Access Compliance Report Public Rights-of-Way (RR Crossings)

Intersection ID: 10025384	Main Street: E_9TH_ST	Location: N/A
ADA ID: 8D064A6BD01E	Overall Compliance: No	Severity Score: 0.0
Codes/Mitigation Info/Possible Solution		Field Measurements/Component Compliance

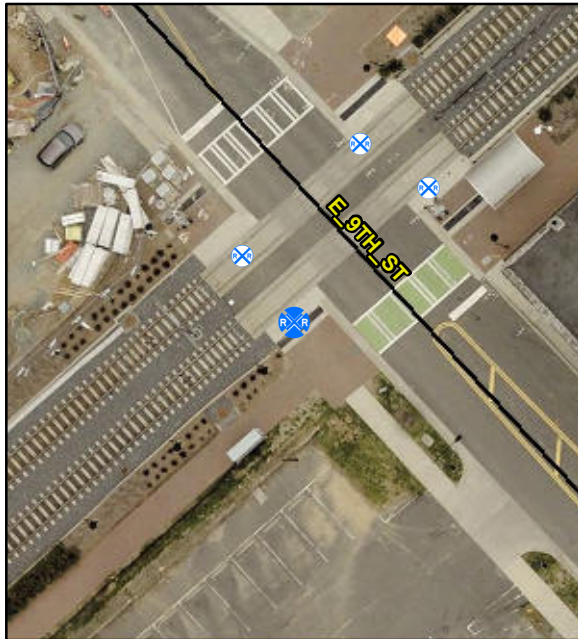
Compliance	Description	Data
Yes	DWS Provided?	Yes
Yes	DWS Contrast?	Yes
Yes	DWS Width (in)	Yes
Yes	DWS Length (in)	24.0
Yes	DWS Offset (in)	72.0
No	Pedestrian Gate?	No
N/A	DWS Outside Gate?	No
N/A	Rail Type?	LightRail
No	Flangeway Gap (in)	2.75
Yes	Sidewalk Width (in)	185.0

**Remove & Replace Detectable
Warning System. Provide Pedestrian
Gate. Remove & Replace Walking
Surface Adjacent to Rail.**
